The authors present a framework for processing the Doppler spectra collected by a vertically-pointing, dual frequency radar operating at the bands Ka and Ku. The framework includes a method for the removal of clutter and range sidelobe artifacts. The resulting clean spectra from three of the operational modes of the radar are merged and used to compute four moments of the spectrum.

Specific comments

(a) Probability density and (b) cumulative distribution of spectral power ratio of meteorological signals between different modes at Ku-band

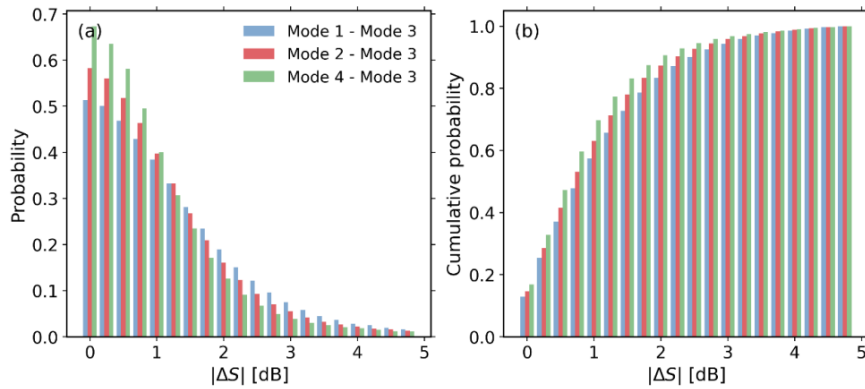
The clutter mitigation algorithm is described clearly. The examples shown in the figures 1 and 3 illustrate its correct functioning when the tail of the power distribution of the precipitation signal is far enough from the 0 m/s fall velocity. In my opinion, it would be useful to briefly discuss in the text how the algorithm reacts in cases in which the meteorological signal is closer to 0 m/s (e.g. light precipitation, drizzle) and there is a more significant overlap between the signal and the clutter. Are there specific cases in which the algorithm fails or mislabels part of the precipitation as clutter?

The declutter method in this paper deals with clutter signals that are not consistent at different observing modes (See Fig.2 in the revised manuscript). In contrast, the meteorological signals are usually coherent and are consistent at different observing modes. If meteorological signals coexist with clutter signals, there are two scenarios:

- 1) If the spectral powers of meteorological signals exceed those of clutter signals, the meteorological signals will be preserved since they are consistent and $|\Delta S|$ is not expected to be large.
- 2) If the spectral powers of meteorological signals are below those of clutter signals, clutter signals will dominate the spectral power. If they are consistent at different modes ($|\Delta S|$ is not very large), they can be mislabeled as

The critical point here is to get a threshold for $|\Delta S|$. As we know, the selection of the threshold is a comprise between false-alarm and miss hit. We want to preserve the meteorological signals at our best, therefore we checked that for the meteorological signals how large the $|\Delta S|$ can be. We attach the statistical plots of meteorological signals (Doppler velocity of 2 ~ 5 m/s) below (Appendix A in the revised manuscript). We have used 3 dB since the probability of $|\Delta S|$ tends to be flat after this value. If a value higher than 3 dB is used, more clutter signals can be mislabeled as precipitation.

“The selection of the threshold is a comprise between false-alarm and miss hit. We want to preserve the meteorological signals at our best, therefore we checked the magnitudes of $|\Delta S|$ for meteorological signals. Figure A1 (Appendix) presents the statistical plot of $|\Delta S|$ for meteorological signals (height of 2 ~ 3 km and Doppler velocity of 2 ~ 5 m s⁻¹). It appears that the probability of $|\Delta S|$ tends to be flat after 3 dB, and the use of 3 dB can ensure that 95.6 % of precipitation cases are well preserved (Fig. A1). Therefore, 3 dB is used in this study. If a larger threshold is employed, we expect more clutter signals will be mislabeled as precipitation.”

(a): Probability distributions of Doppler spectra at 2.4 km (liquid precipitation), 5.01 km (melting layer), and 6.6 km (solid precipitation) at mode 2; (b): Probability distribution of Doppler spectrum recorded at 5.01 km.

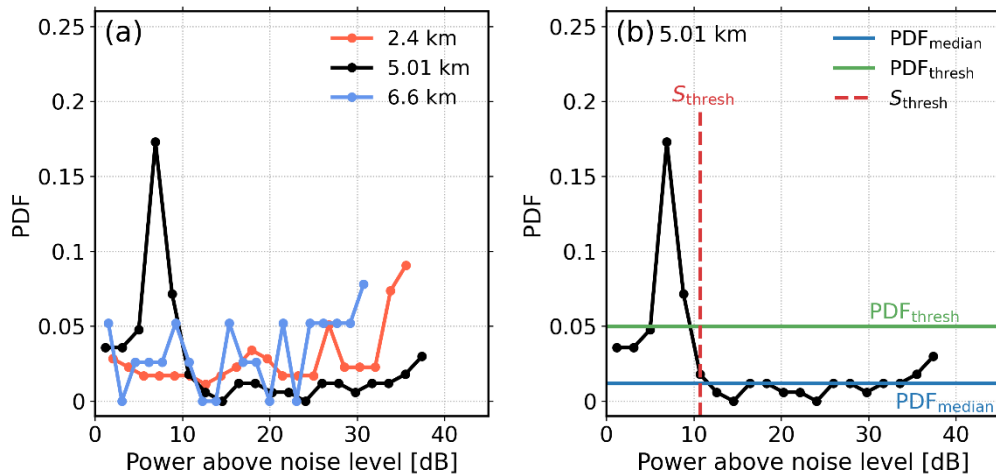
From what I understood from panel (a) of figure 4, the term “uniform” may be

confusing here. If I understood correctly, what is meant by this sentence is that the PDF observed at different range gates are similar to each other, in absence of the sidelobe issue. If this is the case, I suggest rewriting the sentence, avoiding the term “uniform”, since it can create ambiguity with the idea of “uniform distribution” (which the various PDF of panel 4.a are not).

- In panel (a) the orange and red curves cover completely the ones below. I would suggest adding some transparency to the lines so that also the curves below are visible. I also suggest inverting the order in which the lines are plotted, so that the light blue ones sit on top of the darker red ones.
- Panel (b) is never mentioned in the main text of the article. Since the quantity S_{thresh} is introduced in line 184 of the text, maybe you could expand the explanation including a mention of the panel (b).

To present the results to the reader more clearly, we modified Fig. 4 in the original manuscript to show only the probability distributions of spectral power of range bins at 2.4 km, 5.01 km, and 6.6 km, which respectively represent the liquid precipitation, Doppler spectra contaminated by range sidelobe, and solid precipitation (Fig. 5 in the revised manuscript). The following descriptions have been added to the revised manuscript:

“An interesting feature of the range sidelobe caused by pulse compression is that its spectral power is much flatter than cloud and precipitation signals. Figure 5a shows the probability density functions (PDFs) of received spectral power at 2.4 km, 5.01 km, and 6.6 km, which respectively represent the liquid precipitation, Doppler spectrum contaminated by range sidelobe, and solid precipitation. For the sidelobe-contaminated Doppler spectrum, It can be seen that the range bins contaminated by range sidelobe have different spectral power distributions, the peak of the PDFs appears close to the noise level and is mostly below 15 dB above the noise level. A closer look into the radar Doppler spectra at 5.01 km (Fig. 6a) shows that the strong PDF peak in Fig. 5b is explained by the relatively flat range sidelobe signals. Here, we introduce a parameter spectral power threshold (S_{thresh}) to distinguish the range sidelobe from meteorological signals.”
